January 19, 2010
090618-0100-1200

Re: SECI Hardee Power Station (PA 89-25)
Amendment Request for Conductor Replacement
Vandolah – Charlotte Transmission Lines
Request for Additional Information

**SECI RESPONSE 2 TO
DEP-SWD COMMENT NO. 2**

FIGURE 4.
 PLAN VIEW - SHEET 1 OF 28
 SEMINOLE ELECTRIC COOPERATIVE, INC.
 VANDOLAH TO CHARLOTTE 230KV RECONDUCTOR
 HARDEE COUNTY, FLORIDA

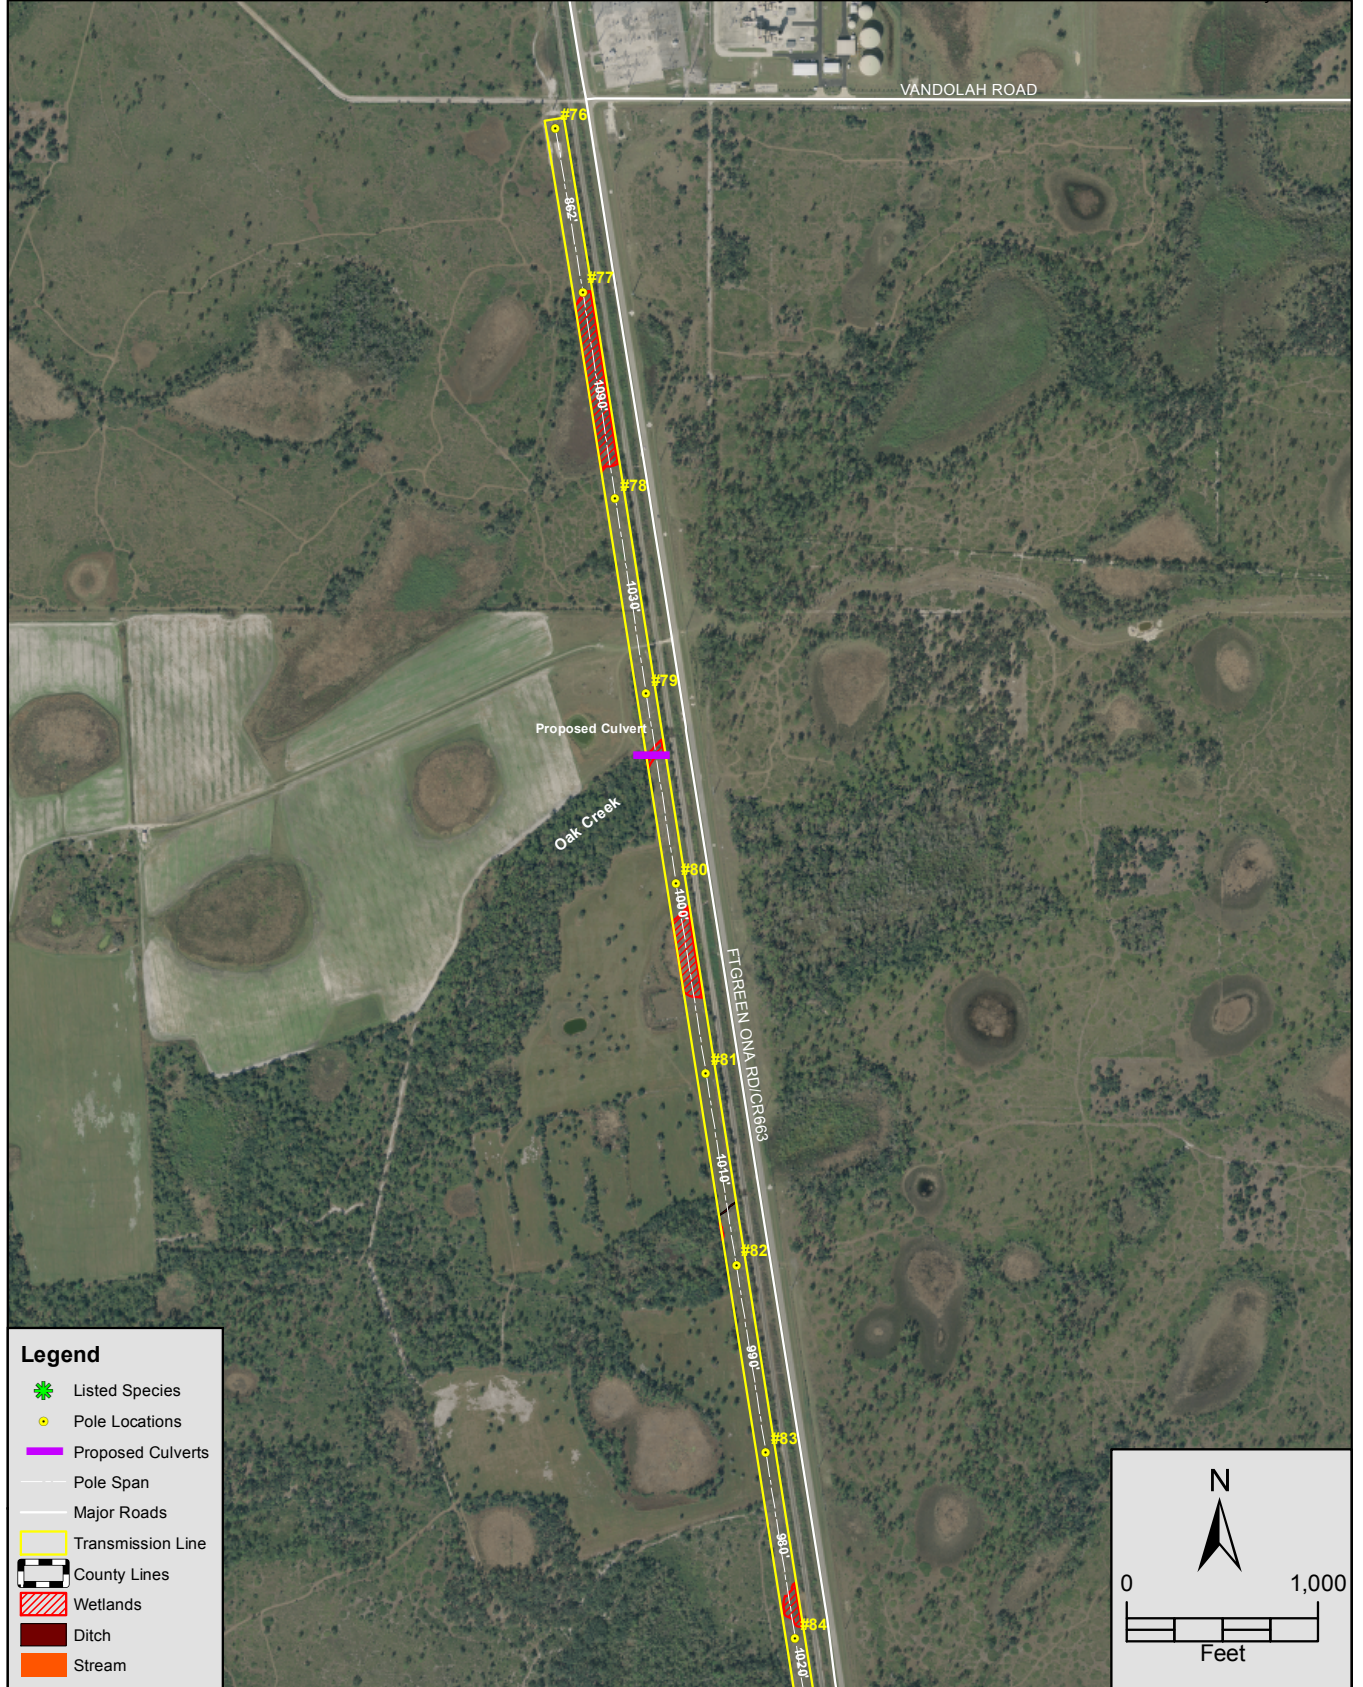
DEP-SWD Comment No 5. Show the locations of the three culverts that will be replaced on the plan view sheets 1 through 28.

SECI Response 5: The locations of the three culverts to be replaced are shown on plan view sheets 1 (Figure 4), 4 (Figure 7), and 14 (Figure 17) of the Application.

FIGURE 28.
 PLAN VIEW - SHEET 25 OF 28
 SEMINOLE ELECTRIC COOPERATIVE, INC.
 VANDOLAH TO CHARLOTTE 230KV RECONDUCTOR
 CHARLOTTE COUNTY, FLORIDA
 Sources: SWFWMD Aerial Photograph, 2007; Prepared by ECT, 2010.

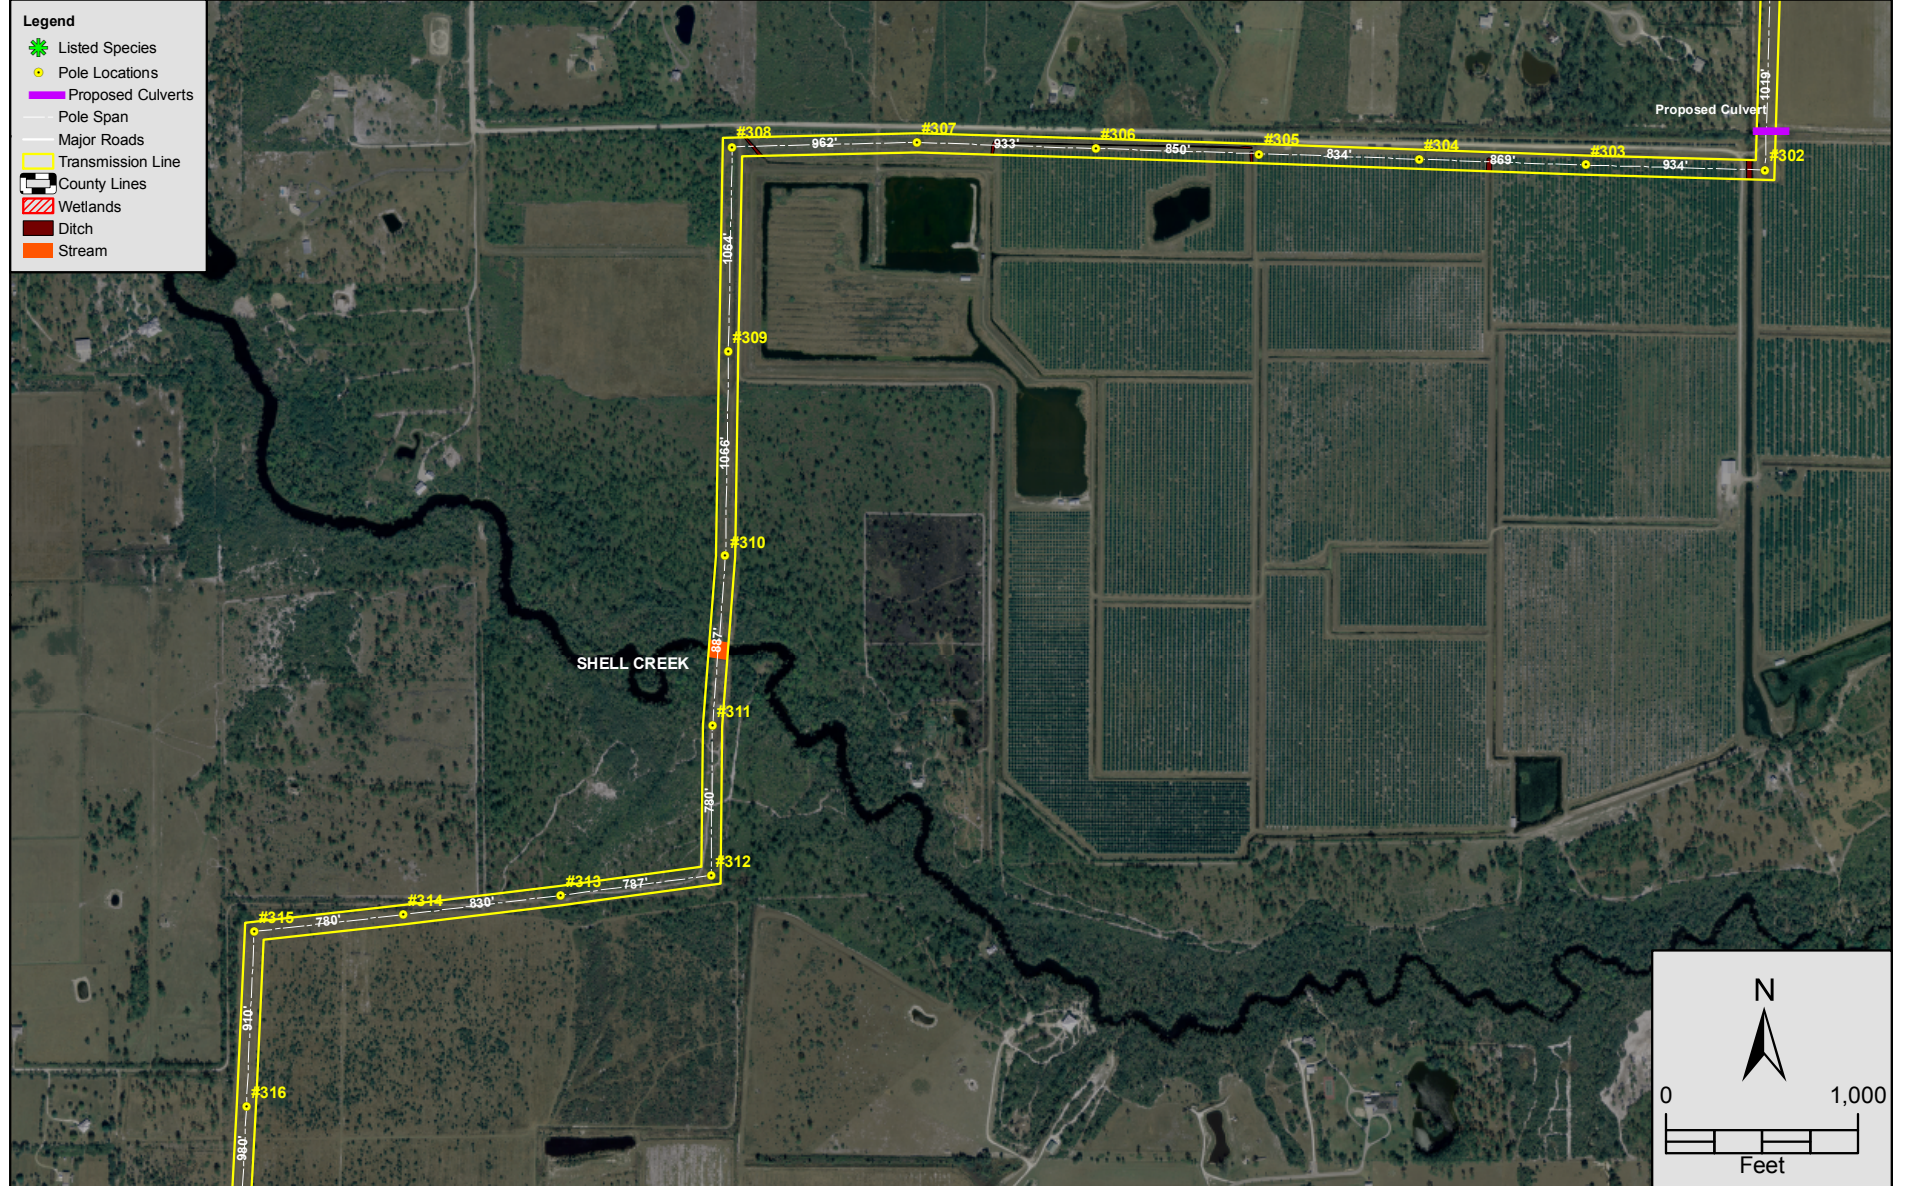
DEP-SWD Comment No 2. The applicant has also applied under 62-341.439, F.A.C. However, that rule applies only to wholly artificial, non-navigable drainage conveyances. Based on aerial photos, it appears that the area proposed for the new culvert is, or was, a natural non-navigable water conveyance. Please provide more information on history and current state of the area that is proposed for a new culvert installation and explain how this culvert installation will qualify for the NGP.

SECI Response 2: After discussion with DEP staff on January 11, 2010, SECI understands that only the drainage crossing located between structures 301 and 302 in Charlotte County (Figure 28, Plan View-Sheet 25 of 28 in the Application) meets the requirements of the referenced NGP (62-341.439, F.A.C.). Therefore, SECI requests that DEP-SWD proceed with review of the three most northern drainage crossings under the standard general permit criteria. Because the culvert installations will have only minimal or insignificant individual and cumulative adverse impacts on the water resources of the district (a listing of dredge and fill impacts by culvert location is provided below), however, SECI also requests that DEP-SWD determine whether the proposed activities qualify for exemption pursuant to Section 373.406(6), Florida Statutes.
